# RESPONSE TO SUBMISSIONS AND PREFERRED PROJECT REPORT

May 2012

This Response to Submissions and Preferred Project Report relates to the Concept Plan by Landcom and NSW Land and Housing Corporation (formerly Housing NSW) for the Claymore Renewal Project (MP11\_0010 and Council Ref 2128/2011/DA-MP). The Claymore Renewal Project seeks to create a sustainable, mixed community. The urban renewal of the area is proposed to address issues of urban structure, housing quality and social mix based on a detailed consideration of the characteristics of the site and its context including the existing community.

**Figure 1 – Concept Plan**

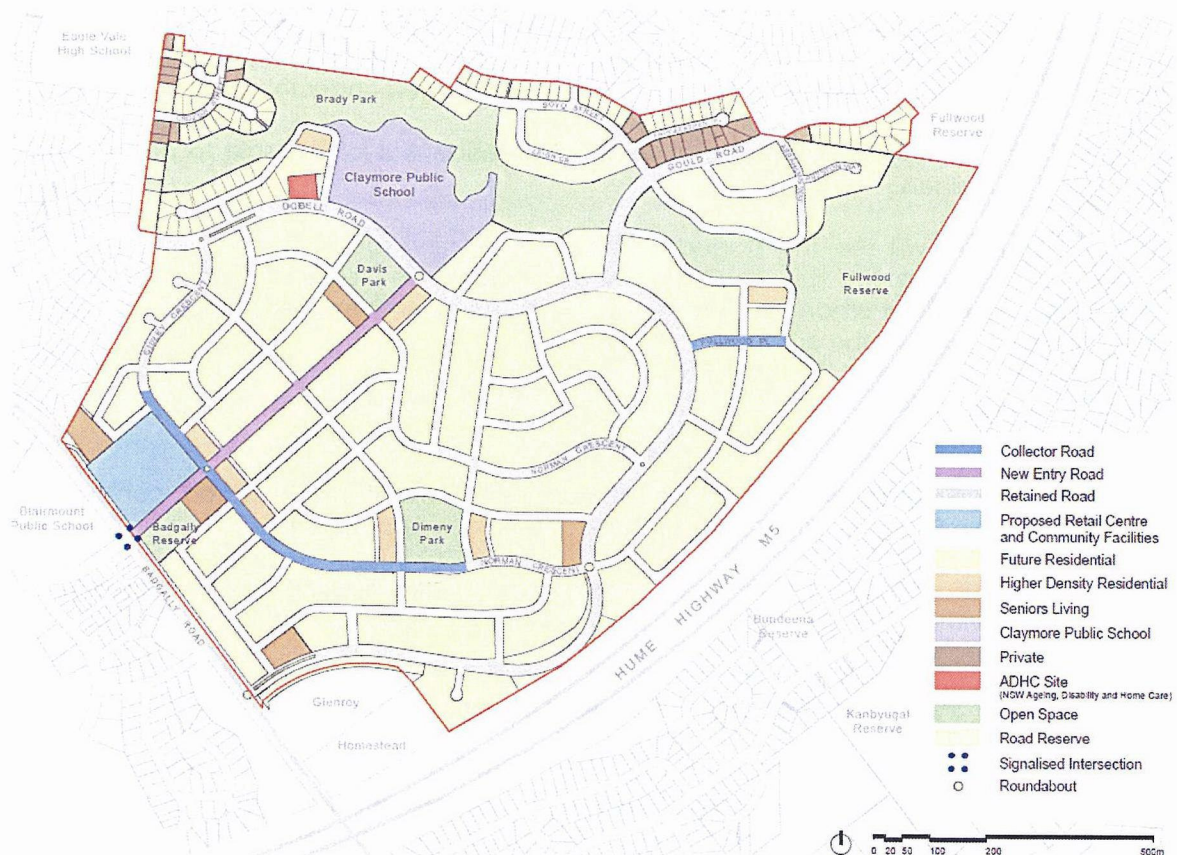
- The proposed development of one lot partly within Lot 2 DP 703539 will reduce the heritage curtilage of the item, and should be revised.

In response to the recommendations in relation to Glenroy, the concept plan has been revised to retain Lot 2 in DP 703539 in its current form.

The response to the above submissions has resulted in a number of minor changes to the Concept Plan for which approval is sought. The Concept Plan is described as follows.
